SERVICE BULLETIN M20-253 A
DATE: 12-95

SUBJECT: M20J ALTERNATE AIR DOOR RETROFIT

MODEL/
S/N AFFECTED: M20J - S/N 24-3244 THRU 24-3250, 24-3252 THRU 24-3374

FIGURE SB M20-253 A-1

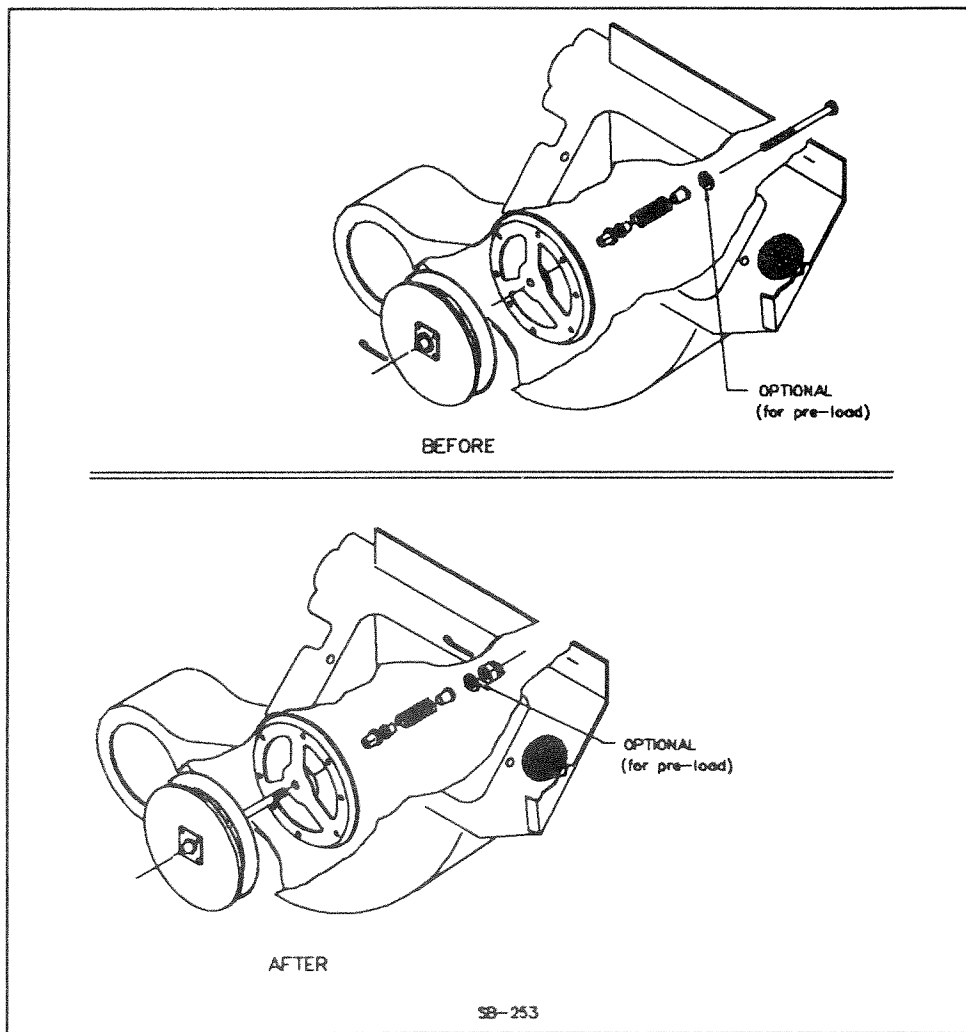
REVISION A is prepared to change part number call outs for a new style nut and a larger OD cotter pin. The Original Issue SB was prepared to change the configuration of the plate assembly (formely "nut plate assembly") and install this new plate assembly on to the existing alternate air door on aircraft. If SB M20-253, Original Issue, has been complied with, and all components are within wear tolerances, only the nut and cotter pin need to be replaced in accordance with SB M20-253, Revision A. Kit number SB M20-253 A-1 contains all components necessary to retrofit an aircraft to the current configuration. Kit No. SB M20-253 A-2 contains only the new nut and cotter pin.

There has been a report of the alternate air door lodging in the induction air duct and restricting induction air flow to the engine. The bolt threads within the modified nut became worn due to vibration. This SB is to change the configuration of the plate assembly and reduce the possibility of this occurring.

SEE
BEFORE AND AFTER
CONFIGURATIONS,
IN FIGURE
SB M20-253 A-1

8. Insert bolt shank of new 600355-507 plate assembly (included in kit) into hole of alternate air door, 600118-015 (from opposite side of rubber seal). Use 4 MS20426AD3 rivets (included in kit) to fasten plate assembly to alternate air door. Use next oversize rivets, if necessary. Align bolt in center of hole as components are being riveted together. Use existing rivet holes in 600118-015 alternate air door. *RIB EC1300 OR EC1300L ADHESIVE*

10. Re-assemble alternate air door assembly (on forward side of aft wall of duct) to doubler assembly (on aft side of aft wall of duct) with nylon bearings, sleeve, spring, **new self-locking/castellated nut (MS17825-4)** and **new cotter pin** (new nut and cotter pin included in Revision A kit).

12. After proper preload is obtained, install new cotter pin, **MS24665-132**, into hole in bolt shank and secure.
13. Re-install lower and upper cowling per Section 71-11-00 of S & M manual.
14. Enter compliance note into aircraft log book and return aircraft to service.
